### UNITED STATES DEPARTMENT OF THE INTERIOR BUREAU OF LAND MANAGEMENT

## PLUG & ABANDONMENT PROCEDURE

# Lindrith No. 29

# CONDITIONS OF APPROVAL

## LINDRITH #2-9

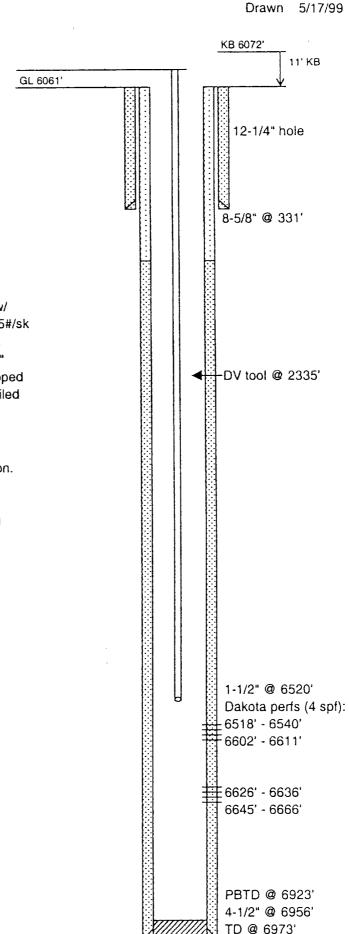
- 1. Plugging operations authorized are subject to the attached "General Requirements for Permanent Abandonment of Wells on Federal and Indian Lease."
- 2. Mike Flanikan with the Farmington Office is to be notified at least 24 hours before the plugging operations commence (505) 599-8907.
- 3. The following modifications to your plugging program are to be made:
- a) Place the Gallup plug from 5571' 5471'.
- b) Spot a cement plug from 3110' 3010' to cover the Chacra top.
- c) Place the Ojo Alamo plug from 1601' 1302' to cover the interval.
- d) Place the Nacimiento/Surface plug from 450' to surface inside and outside the 4 ½" casing.

You are also required to place cement excesses per 4.4 of the attached General Requirements.
